STATE OF HAWAII
DEPARTMENT OF TRANSPORTATION
HIGHWAYS DIVISION
UTILITY PLAN
MAUNA KEA MAINTENANCE
BASEYARD
DANIEL K. INOUE HIGHWAY
Project No. 200A-01-10
Scale: As Shown Date: April, 2018

1	06-07-18	ADDENDUM NO. 4	
REVISION	DATE	DESCRIPTION	AA15

STATE OF HAWAII
DEPARTMENT OF TRANSPORTATION
HIGHWAYS DIVISION
SHOP BUILDING
MAUNA KEA MAINTENANCE BASEYARD
DANIEL K. INOUE HIGHWAY
Project No. 200A-01-10

E2.01

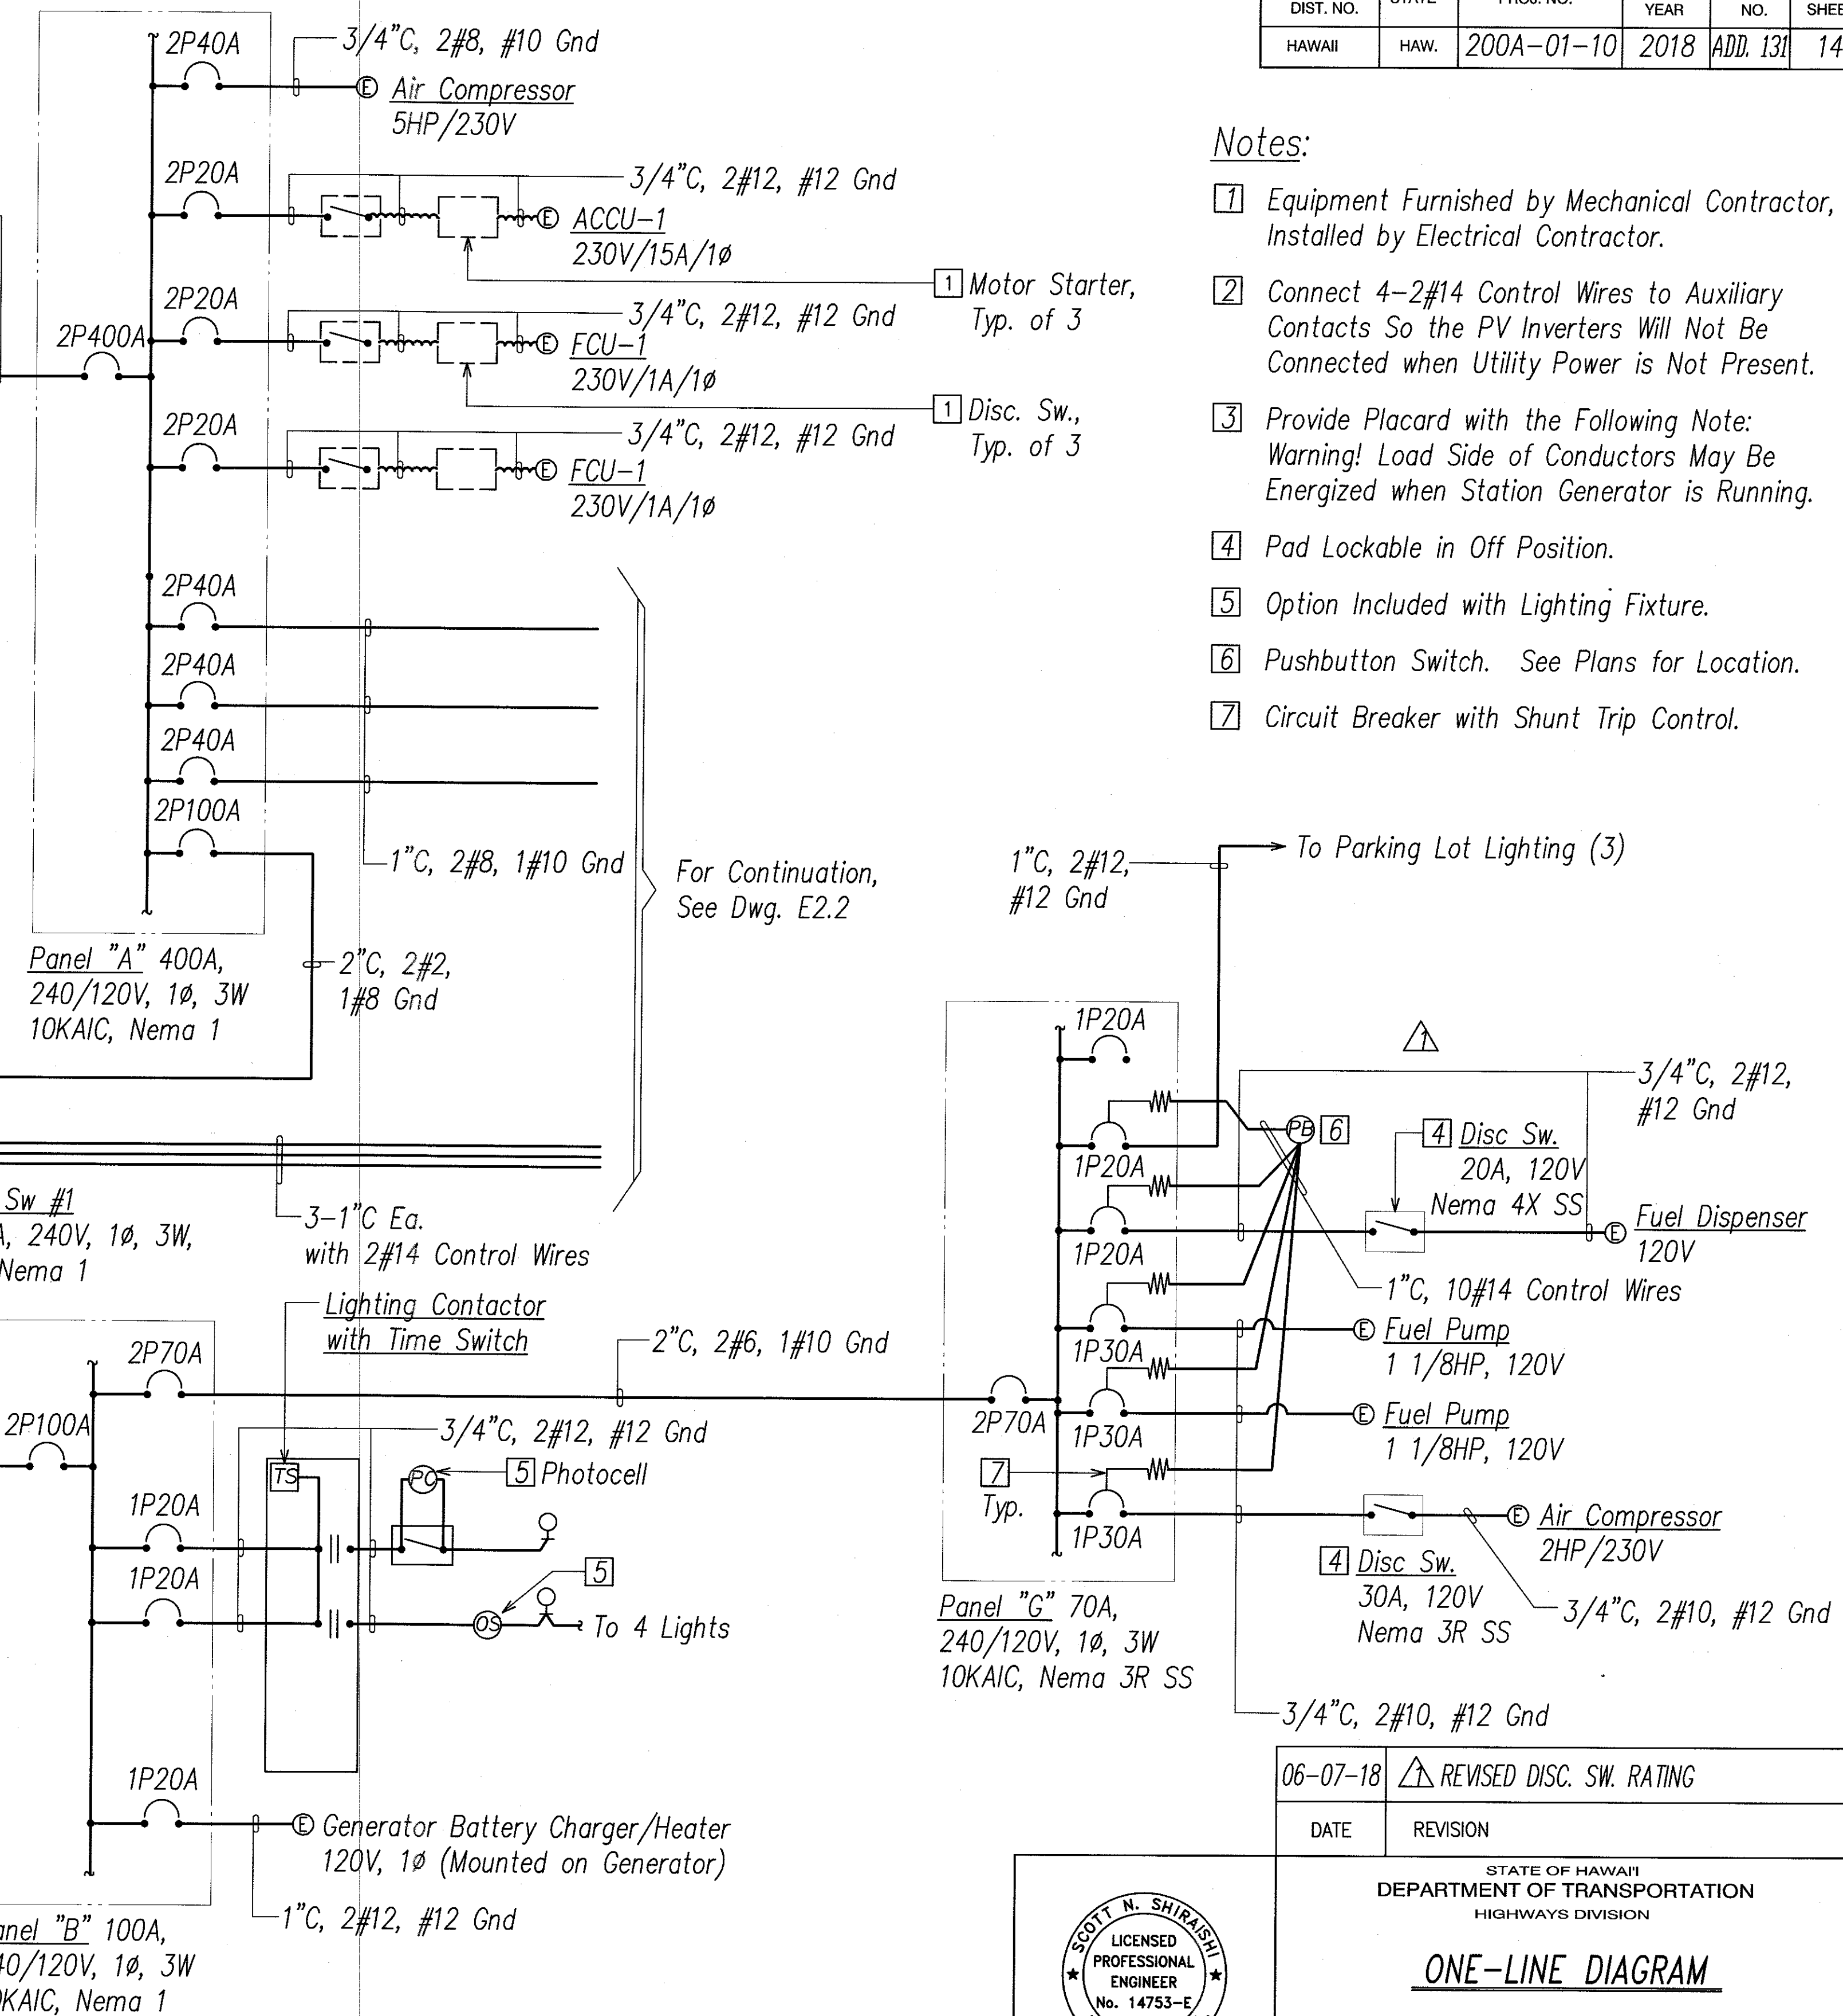
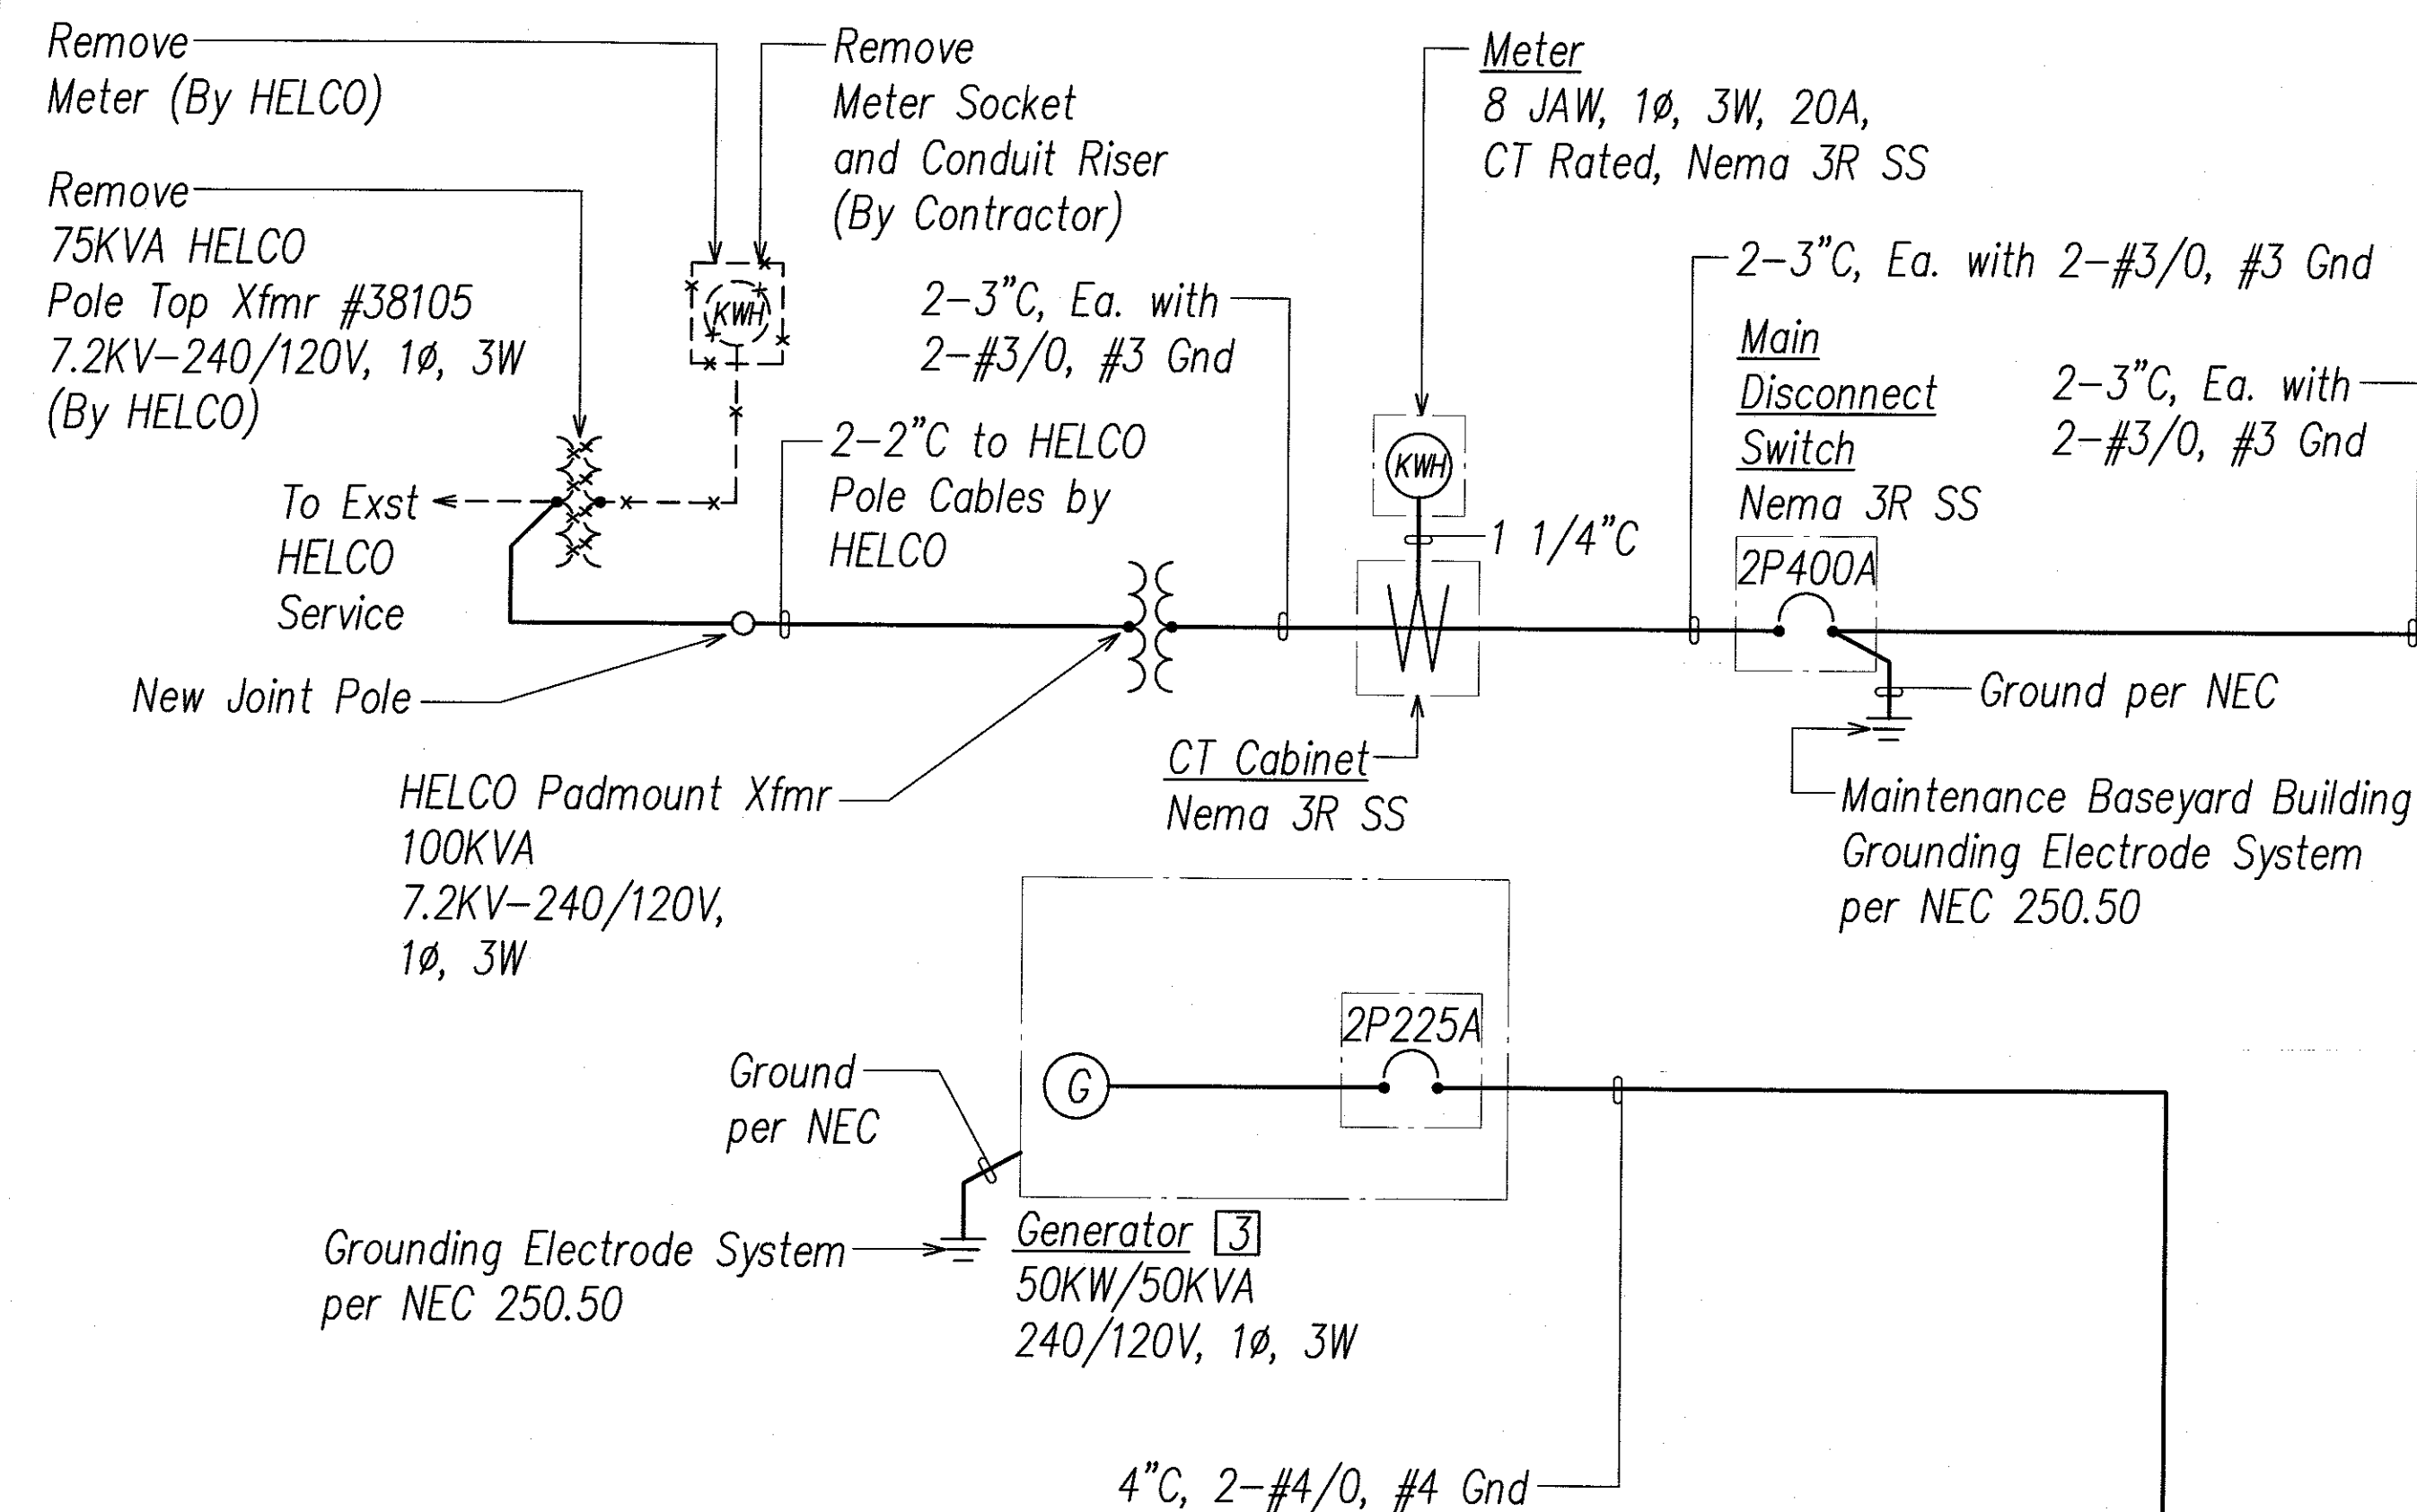
06-07-18	 REVISED DISC. SW. RATING
DATE	REVISION
